Inspection of Automatic Sprinkler System

Bushveld Energy

UNC.9855

Bushveld Energy
ELIDZ (East London Industrial
Development Zone)
ERF 60936

Photo 26

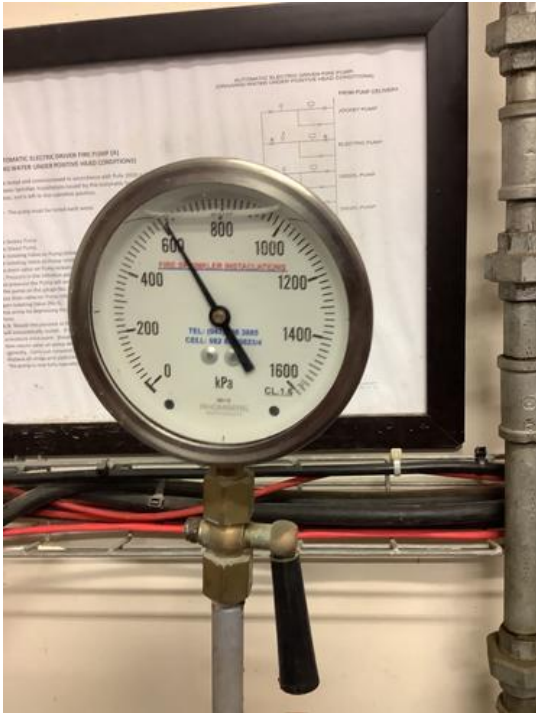
No

Photo 58

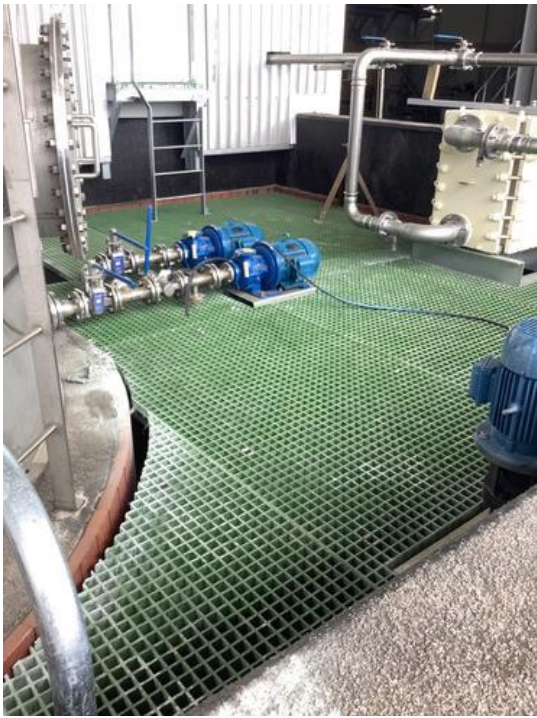
Surfaces exceeding 1,0 metre in width.

Surfaces which exceed 1,0 metre in width will obstruct the water discharged from the sprinklers above which could result in an ignition beneath these surfaces not being controlled or extinguished.

All areas that are wider than a meter and any enclosures. As the production areas were still being installed at the time of inspection these could not all be verified
